File 1983-0021
Date 9/26/02

Project Name: 1st National Bank – Vacation of alley between Grand & White

REVIEW SHEET SUMMARY

FILE NO. 21-83 TITLE HEADING Vacation of Alley DUE DATE 4/14/83

yes
Plan B

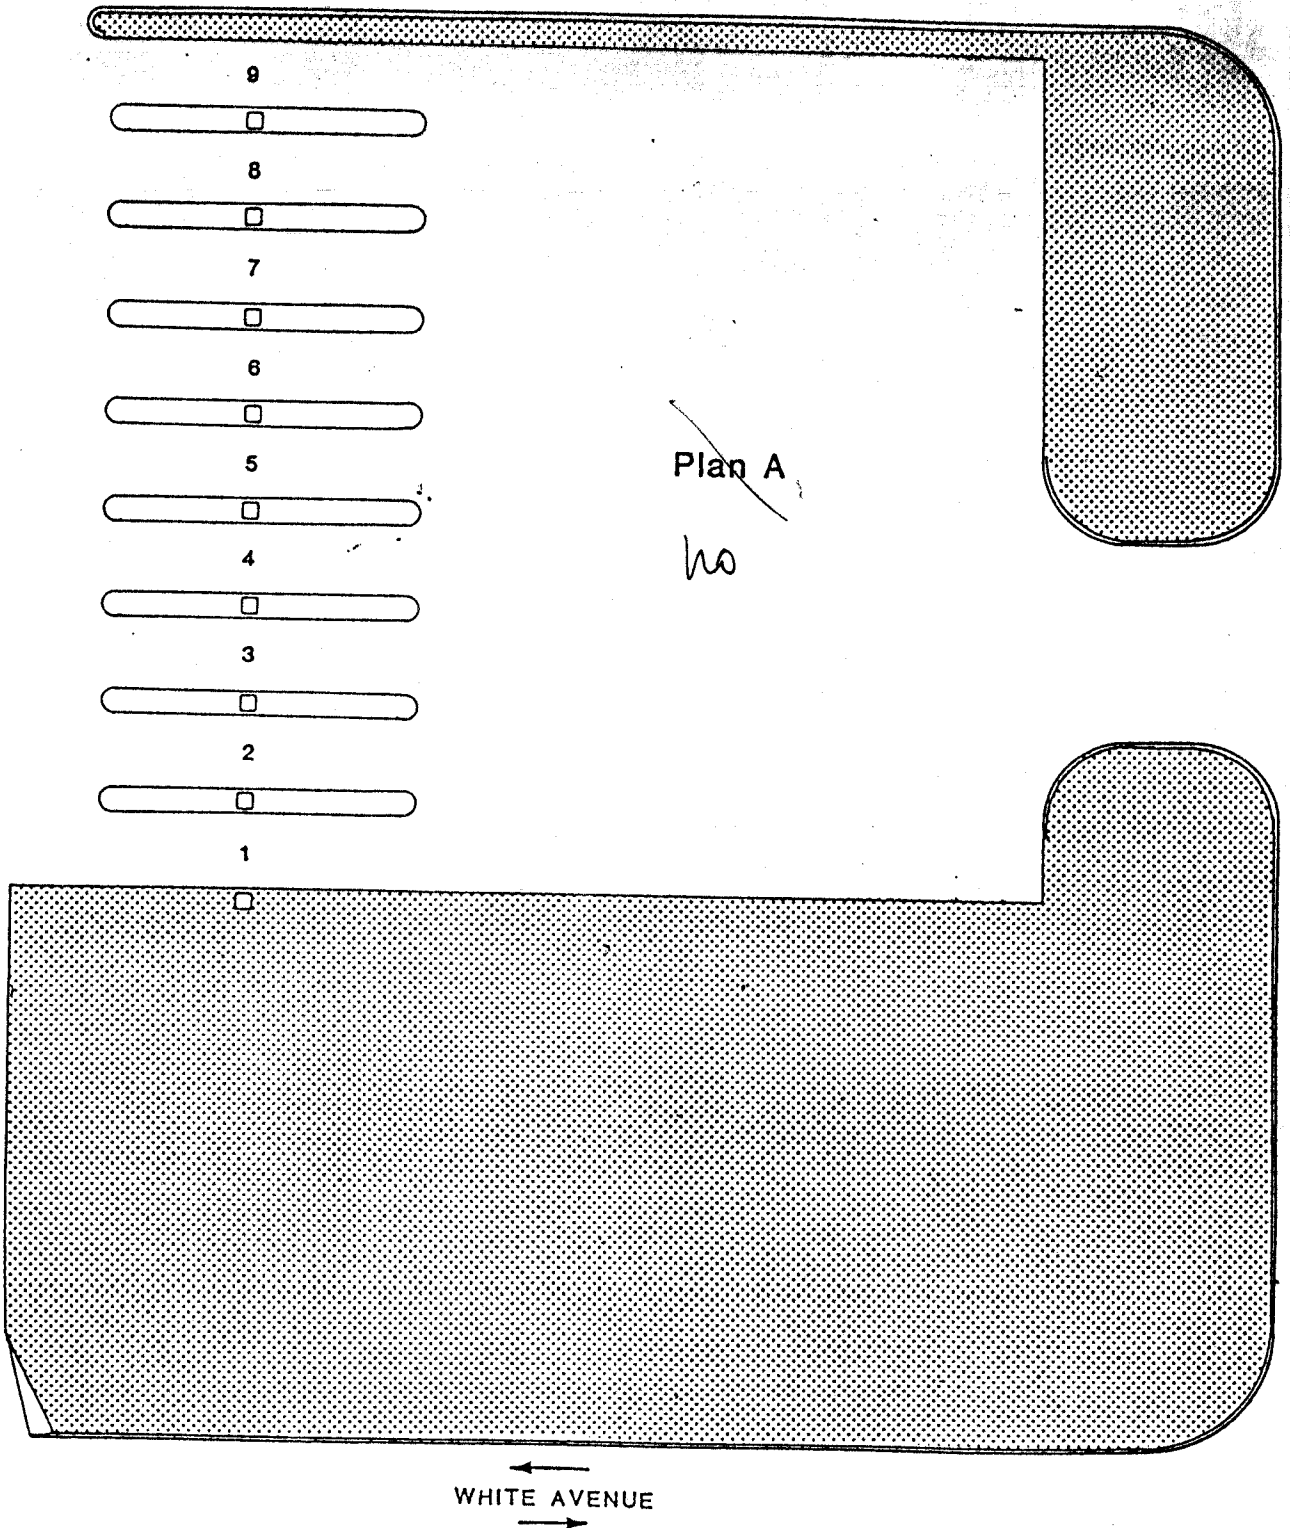
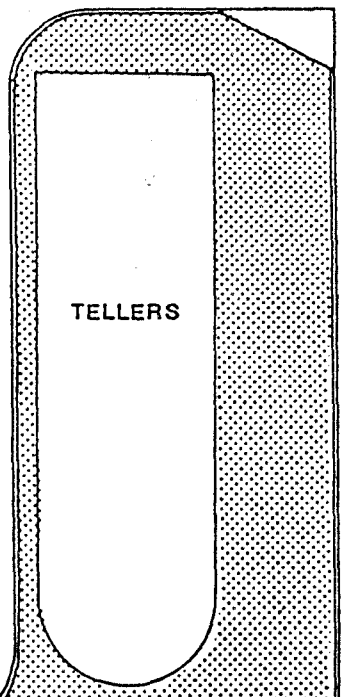
We have reviewed the two attached plans of a new drive-in facility for the First National Bank in Grand Junction. Plan A is characterized by entry from 5th Street with a west movement through the drive-in area and an exit to White Avenue. Plan B shows entry off White Avenue to an alley and then an east movement through the drive-in to an exit on 5th Street. Fifth Street is operated as one-way northbound while White Avenue is a two way operation.

Both plans are designed to provide nine drive-in stations, two commercial and seven personal, an increase of 55% over the 4th Street and Rood Avenue facility which it will replace. Also as given conditions will be an increase of tellers from a maximum of three to a maximum of six and a mode of operation wherein all stations will be open whenever the facility is in service. This latter point simplifies the decision process of the drivers in selecting the most desirable lane by allowing them to go to any lane that is open without checking to see that it is in service.

Plans A and B are good in that they provide a facility totally separated from other Bank vehicular and pedestrian traffic while providing for vehicular movements which are both simple and direct. The design is also most generous of space allowing for other than minimum radius turns.

Plan B we see as providing a good view of all the windows by a glance to the right as the drivers enter the alley.

Plan A is flawed by a requirement that drivers make a decision on lane selection as soon as they enter the facility from 5th Street. This is a condition which should be avoided since it may cause a driver to hesitate or move erratically and perhaps be involved in a collision. Plan A also provides an exit to White Avenue, a two way street. Delays to drive-in patrons and other users at the alley are more likely to occur due to drivers attempting to negotiate left turns across traffic moving in one direction to merge with traffic moving in the opposite direction. During peak traffic periods this can be difficult. By comparison Plan B shows traffic discharging into a one-way street where the driver will have only a merge maneuver to negotiate.

Our recommendation is to implement Plan B because of its better entrance and exit conditions, its easier lane choice and its potential for greater efficiency.

Figure 1

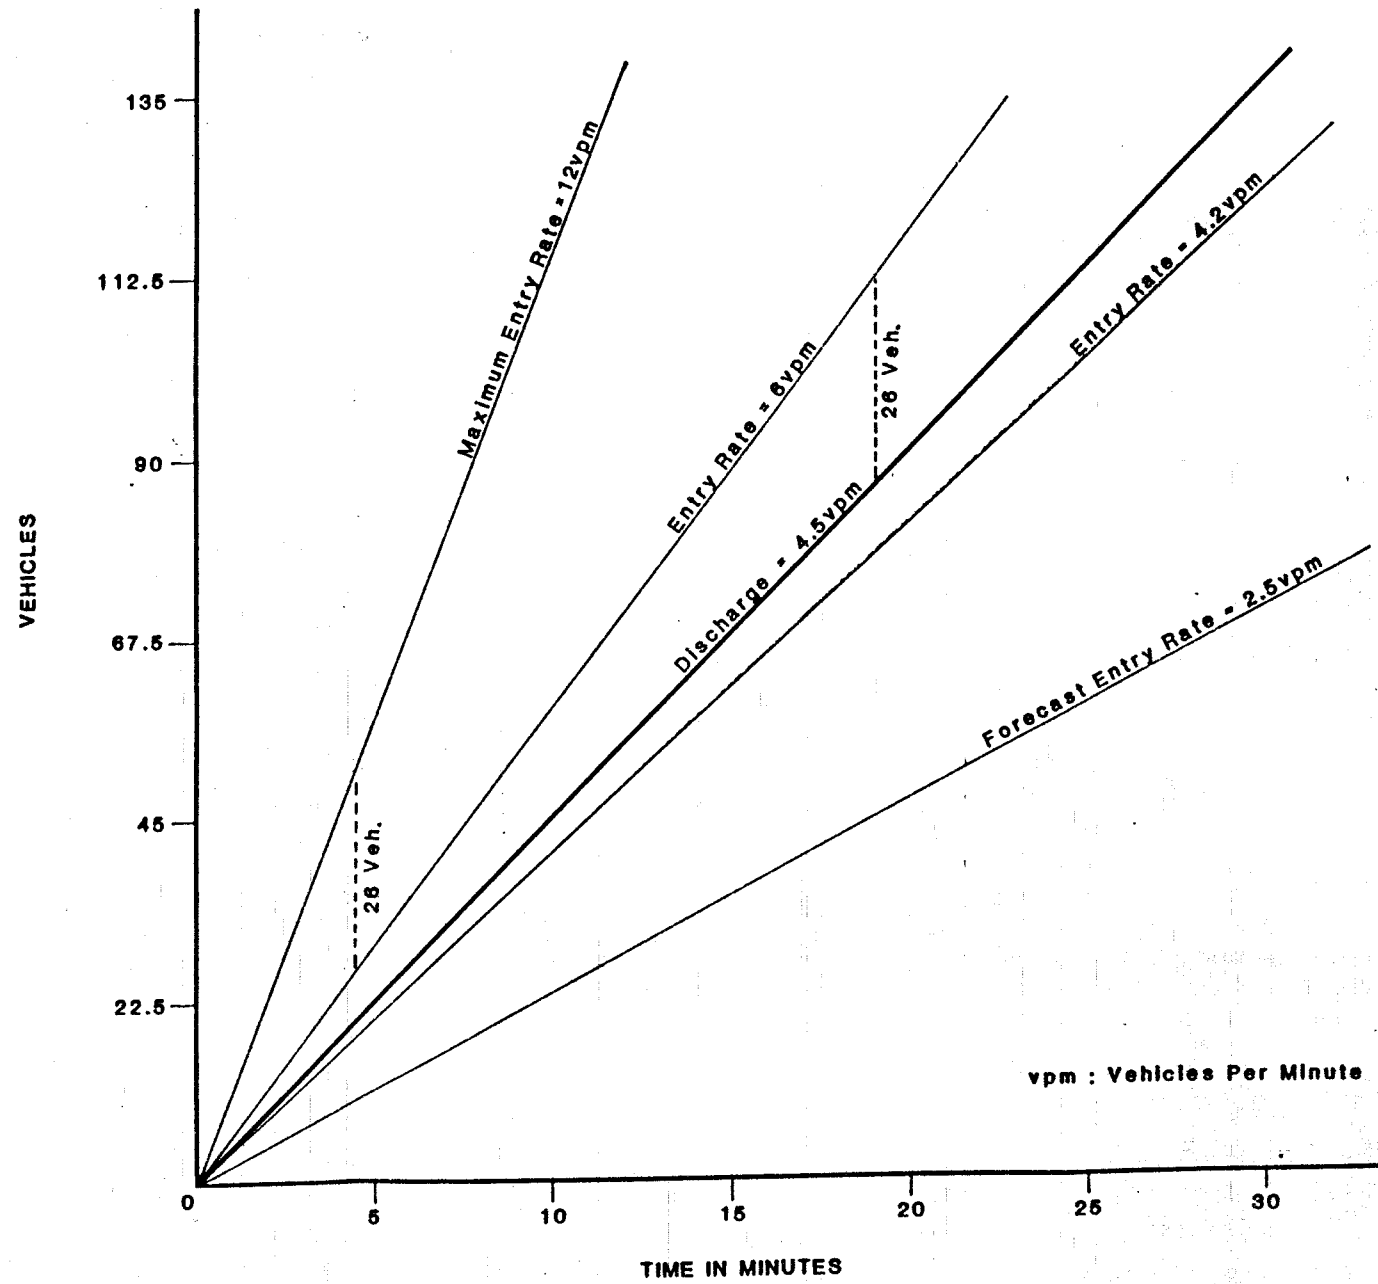
Using the greatest generation figure encountered, 28 vehicles per window entering during the bank's peak hour (Reference 4, Appendix I), it is unlikely that the 26-car reservoir provided by Plan B will be fully utilized. Actually, the discharge rate is higher than the entry rate for any service rate data given in the literature, or found in our experience. Figure 1

was prepared to illustrate these points. The two vertical lines marked "26 vehicles" show vehicular accumulations where the reservoir will overflow, but in both cases, the entry rate is higher than the data indicate will be encountered.

Drive In Facilities
First National Bank in Grand Junction

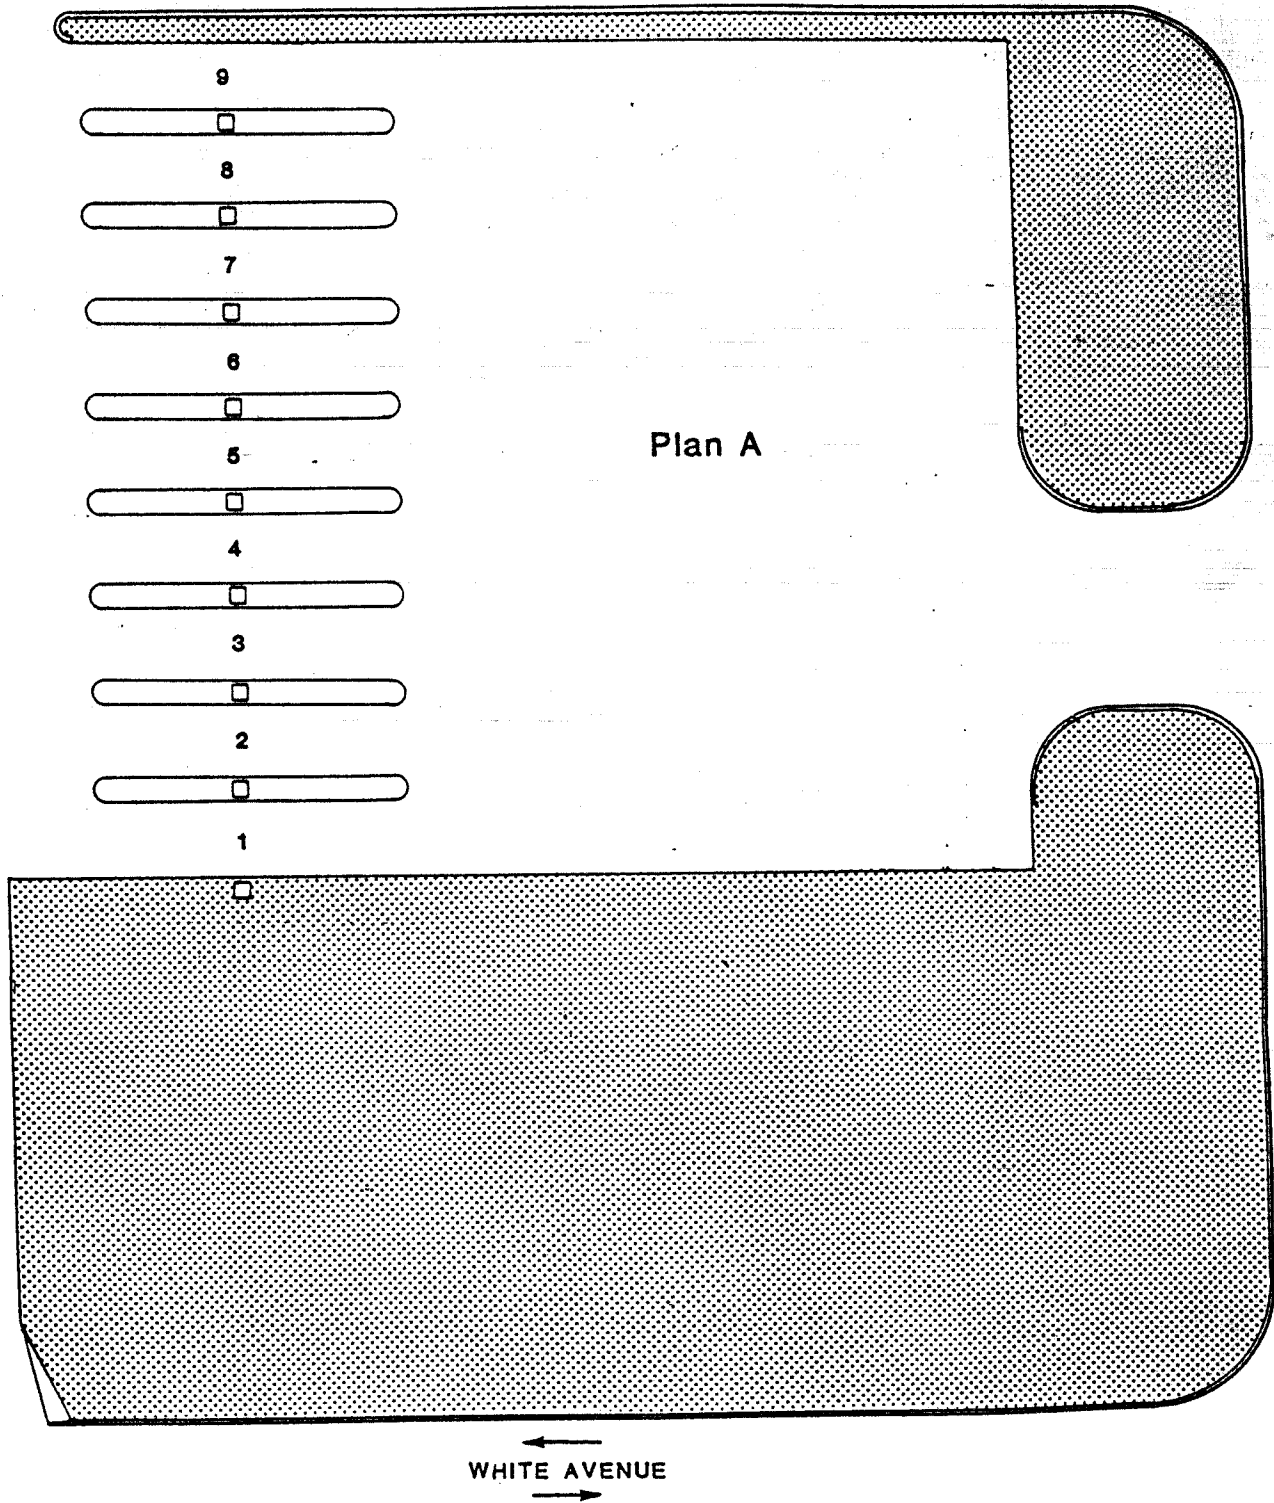
The question of site entry and exit was examined from both a theoretical, and pragmatic viewpoint. During the evening peak hour traffic, the bank will generate an estimated 85 vehicles exiting to 5th Street. The two stores north of the site are estimated to generate 45 exiting vehicles, two-thirds of which will use the alley to enter 5th Street. The combined total of vehicles estimated to be leaving the site during the peak traffic flow on 5th Street is 115. This will be one vehicle every 30 seconds on the average.

If Plan A is implemented by the bank, the 115 vehicles will all use the eastbound alley to enter 5th Street. The most serious problem will be the conflict with southbound pedestrians stepping out from behind the sporting goods store.

If Plan B is implemented, only 30 vehicles will be using the alley, with 85 using the adjacent bank driveway. Visibility will be good for both the drivers on the parallel paths and on 5th Street. Visibility will require restriction of parking on the west side of 5th Street for at least 50 feet south of the south curb line of the driveway.

The apparent restrictions to visibility for Plan B exiting vehicles involve the columns between the alley and the driveway and the tellers building on the south side of the driveway. The columns are widely enough spaced (15 feet on centers), that two drivers, one in the alley and the other in the driveway, can see each other and even make eye contact before entering 5th Street. The tellers building is set back 12 feet from the west curb line of 5th Street and the driver of a mid-size car is approximately nine feet from the front extremity of the vehicle. Therefore, when stopped at the edge of the sidewalk, the driver can see anything on the sidewalk within 35 feet of the vehicle. When the driver is stopped at the curblines prior to entering 5th Street, visibility is virtually unlimited provided parking is restricted at the west curb line.

Visibility for the drivers of vehicles entering the bank site is excellent for either Plan A or B.

I have reviewed the traffic engineering analyses performed by Leigh, Scott & Cleary, Inc. In accordance with the agreement made at our May 20, 1983, meeting, I will accept the findings of Leigh, Scott & Cleary, Inc., that the proposed PLAN "B" will not adversely affect the traffic operations on White Avenue or 5th Street and that "the drive-in traffic to the First National Bank of Grand Junction will not block or interfere with traffic in the alley". There were also some recommendations concerning stop signs, pavement markings and parking restrictions that should be implemented.
